Management Control Program 5.2

POWERTECH (USA) INC.

TR Section 5.2

Figure 5.7-11: Operational Environmental Monitoring Sites

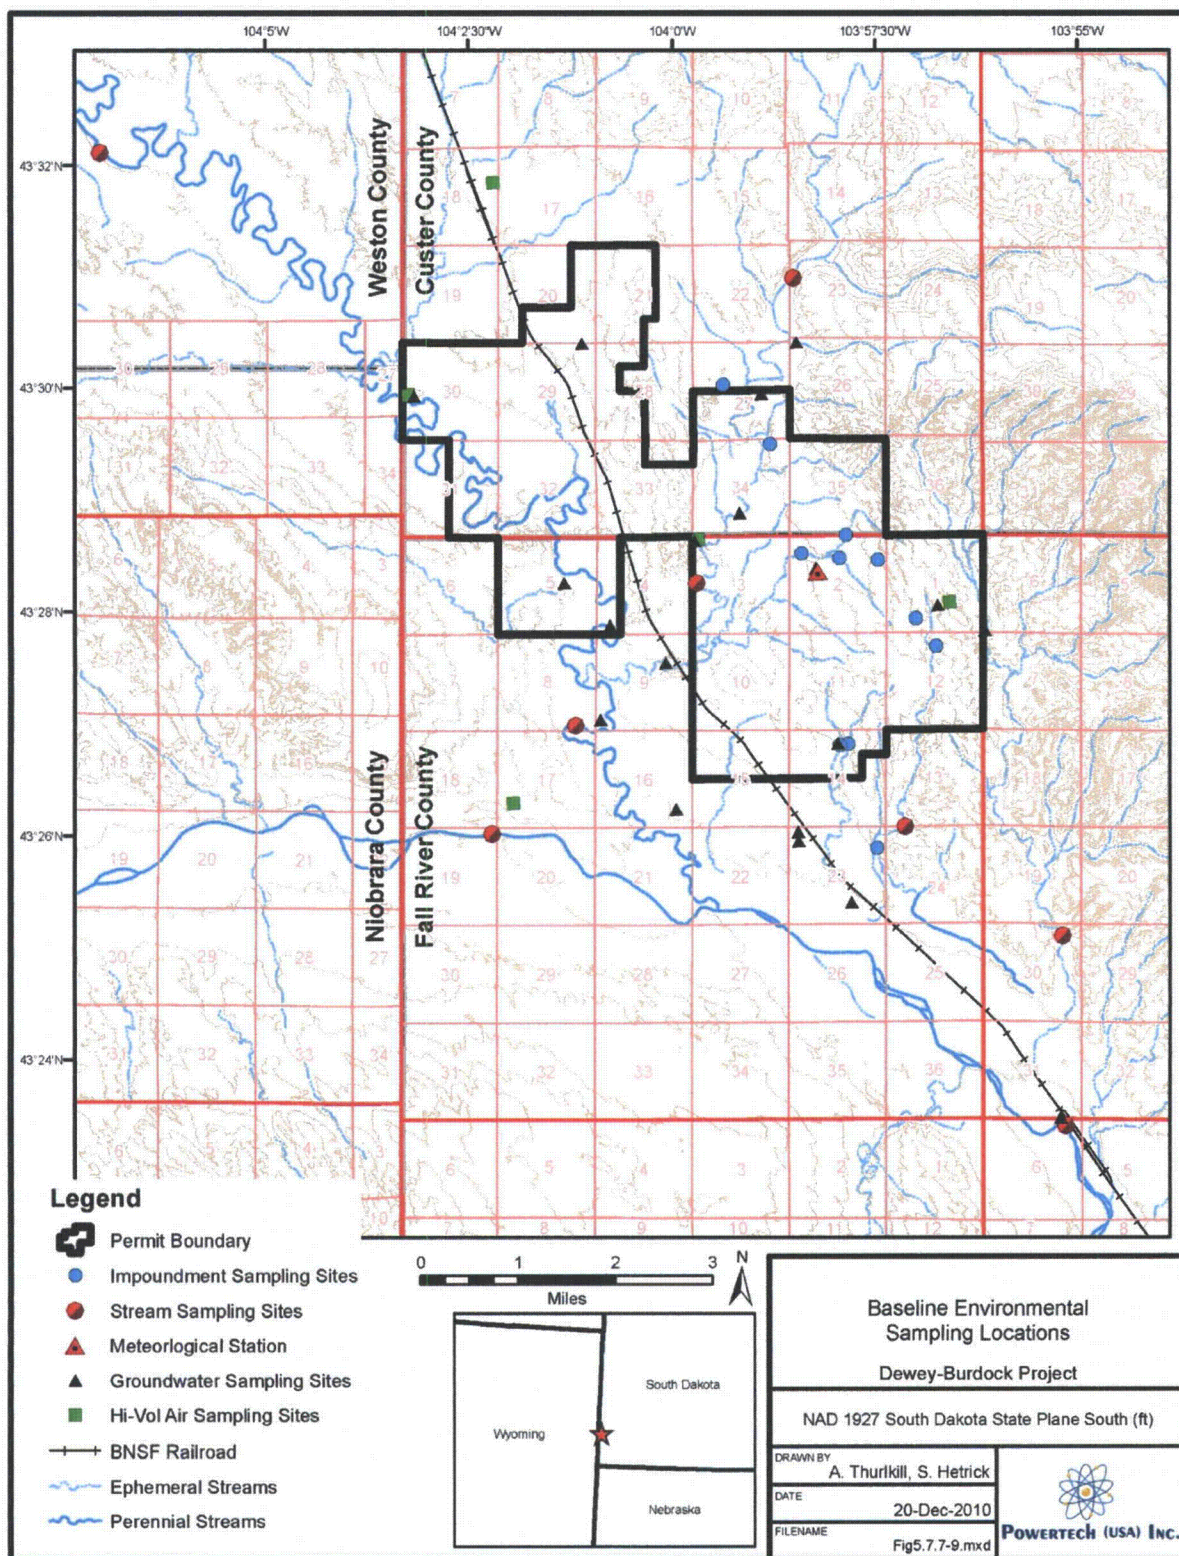
In Section 2.7.3.1 of the TR the applicant identified 48 surface water impoundments. However, in Section 5.7.8 of the TR, the applicant identified only 11 impoundments in its operational surface water monitoring program as shown on Figure 5.7-10 of the TR.

See TR_RAI-Response Response 5.7.8-9 for (Figure 5.7-11) the scale of the map has been adjusted to depict all surface water sampling locations upstream of PAA and downstream of PAA.
